# ATTACHMENT 1

26 October 2011

**Subject: Creekside Memorial Park Cemetery Draft Environmental Impact Report—Review of Water Use and Supply Calculations**

Figure 1. Confined aquifer: drawdown contours after one annual irrigation cycle.

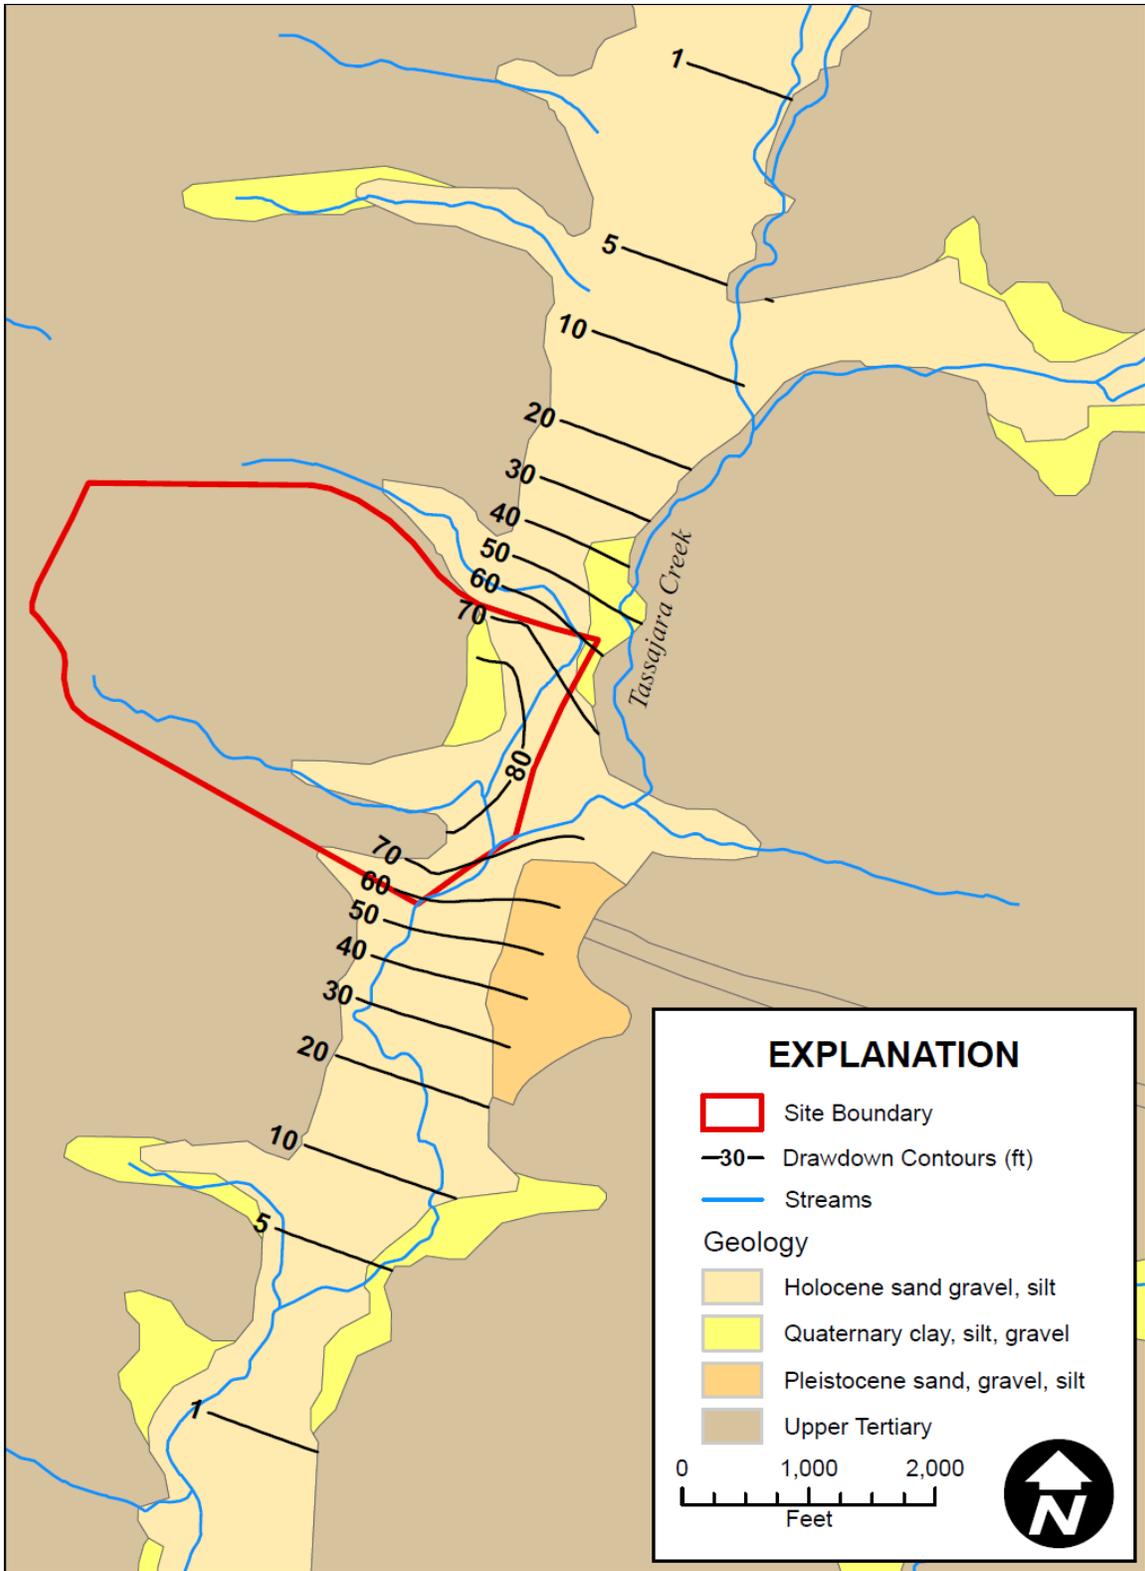
The calculated drawdowns indicate project groundwater use will likely substantially lower groundwater levels and deplete groundwater storage. After one annual irrigation cycle, the drawdown in the pumping wells ranged from 67 to 87 feet for assumed confined aquifer conditions, and 22 to 23 feet for assumed unconfined aquifer conditions. The cone of depression extends significant distances beyond the site boundaries. Under assumed confined conditions, the cone of depression extends almost one mile to the northeast and southwest past the site boundaries (See attached Figure 1). Under unconfined conditions, the cone of depression extends on average about 500 feet to the northeast and southwest past the site boundaries (See attached Figure 2).
